SAFETY RECALL SERVICE BULLETIN

CP-400-H

CP-400-CA

Draft hook retaining nut recall (NHTSA recall No. 02E-041) for CP-400-H and CP-400-CA

FIGURE 8

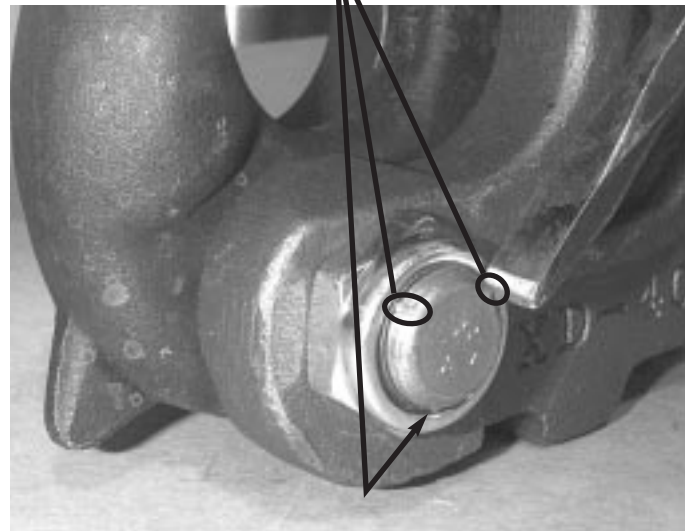
5. Torque the nut to a minimum of 50 ft-lbs. Make sure that the jaw can still rotate freely on the bolt.
6. If you do not have any Loctite you must stake (deform) the exposed threads of the bolt in three places around the bolt, as shown in **FIGURE 8**.

STAKE THE BOLT END
